## SICHERHEITSMITTEILUNG für Gurtzeuge

Nummer: 01/2016 3. Ausgabe (Update) Erweiterung der SM vom 18. Jan. 2016

## PRODUCT SERVICE BULLETIN 2016-01 (PSB # 2016-01) Update 2

**SUBJECT:** Stainless Steel Base Ring Hardware on Vortex Harness Containers with DSF stamp or Daesung logo (as pictured)

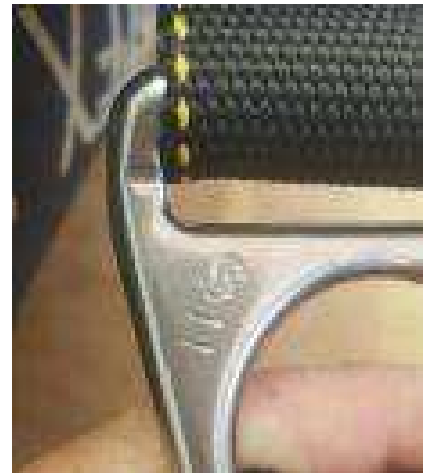
Betroffene Muster: **alle Vortex Gurtzeuge mit Hardware aus Edelstahl bei dem das Logo „DSF“ und zusätzlich die Hardware, bei denen wie im Bild dargestellt, das Logos auf der Hardware eingepreßt ist. Eine kleine Anzahl von Gurtzeugen wurde im Jahr 2011 mit dieser Hardware produziert.**

A small number of harness containers were produced by Parachute Systems in 2011 with stainless steel base ring as pictured below:

These DO form part of the recall and are in addition to the ones referenced in the original Bulletin (PSB#2016-01) stamped "DSF".

The original Bulletins are hereby corrected and should include the harness containers with the rings stamped as this picture indicates. All references in all Bulletins and Notices include products with either one of these stamps on the stainless steel base rings.

Status: **Die betroffenen Gurtzeuge mit dieser Hardware sind für immer gegroundet!**

Maßnahmen: Die betroffenen Gurtzeuge müssen zum Hersteller geschickt werden. Im Tausch baut dieser ein neues Gurtzeug auf Grundlage der originalen Bestellung mit neuer Hardware. Dieses wird nach neuestem Standart mit Skyhook-Vorbereitung und Magnetic Cover für die Riser gefertigt. Größen- oder Optionsänderungen sind gegen Aufpreis möglich.
